## MONTGOMERY COUNTY HISTORIC PRESERVATION COMMISSION STAFF REPORT

Address: 198 Market Street, Brookeville Meeting Date: 1/22/2025

Case No.: 1097741 Staff: Laura DiPasquale

**Proposal:** Fenestration alterations

Figure 2: Locations of the proposed door and window replacements (denotated with red Xs).

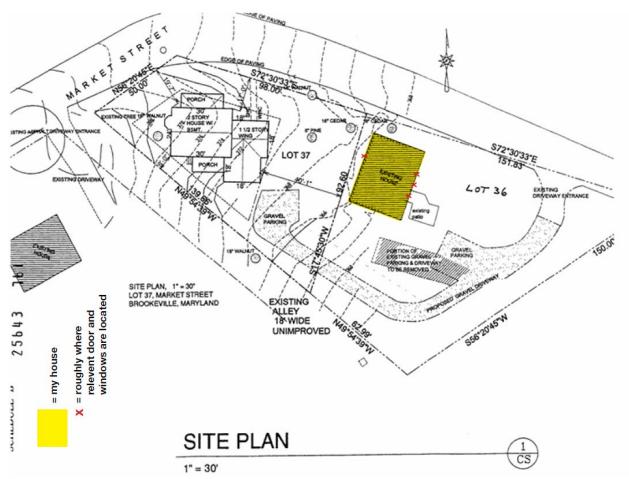
The applicant proposes to replace one wood entry door, replace one existing attic window, and to restore two original infilled window openings. The proposed door would be steel with internal grids. The proposed windows would be vinyl with internal grids.

#### **Entry Door**

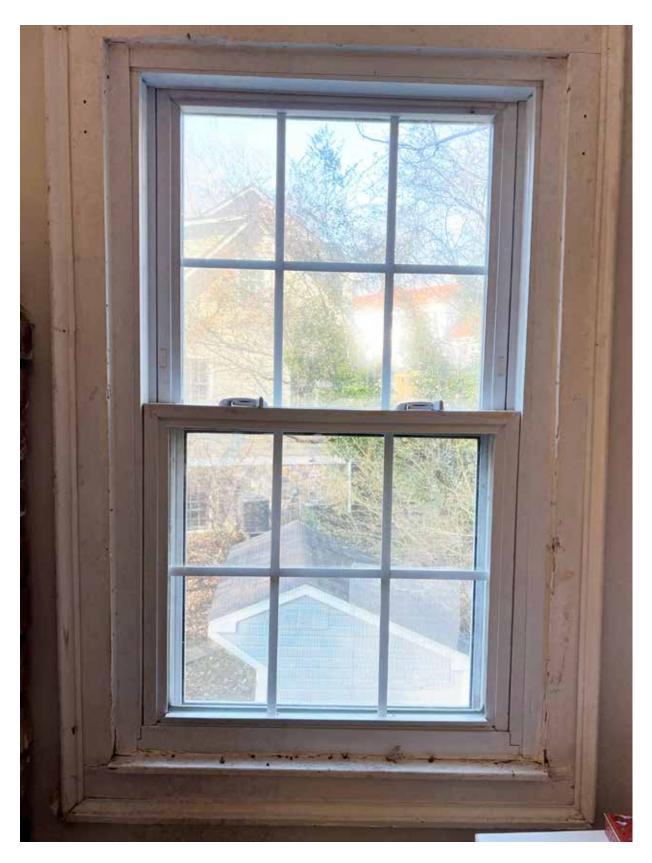
The applicant proposes to install a half-light steel door with internal grids (*Figure 5*). Staff finds that the existing wood side door is in poor condition and is not original to the opening, as evidenced by the proportions of the bottom rail, which has been cut to roughly two inches in height, leaving very little space below the panels above and reducing the door's structural integrity. Weather stripping has been

applied to a crack in the door, and one pane of glass replaced with plexiglass. Staff finds that the proposed steel door with internal grids is not compatible in materials or design with the historic property or district, but supports the replacement of the door with a new wood door that is in keeping with the style and age of the property and its modifications, satisfying Chapter 24A-8(b)(2).

- 1. The new windows must be true or simulated-divided-light wood or aluminum-clad windows with 7/8-inch muntins. No internal grids may be used.
- 2. The replacement door must be paneled wood and must have true or simulated-divided-lights or no glazing. No internal grids may be used.
- 3. The applicant must submit specification/shop drawings to staff showing details of the proposed windows and door in elevation, section, and plan, including how the units will be installed within the openings.

## Attic windows (install two smaller windows that historically existed but were covered by previous owner)

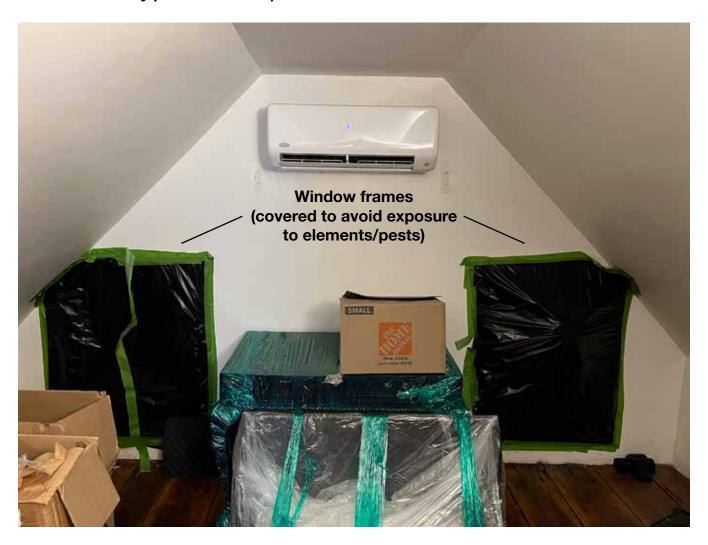
Staff finds that the reinstatement of the two currently-infilled attic windows is substantiated by the physical evidence of the frames and openings on the interior of the house (*Figure 9*), in keeping with *Standard* 6, and that the proposed pane configuration appears to be compatible in scale and proportion to the historic resource, as would six-light casements, in keeping with *Standard 9*, but the vinyl material and internal grids are incompatible with the character of the historic resource, failing to satisfy Chapter 24A-8(b)(2), *Standard* 6 or 9.
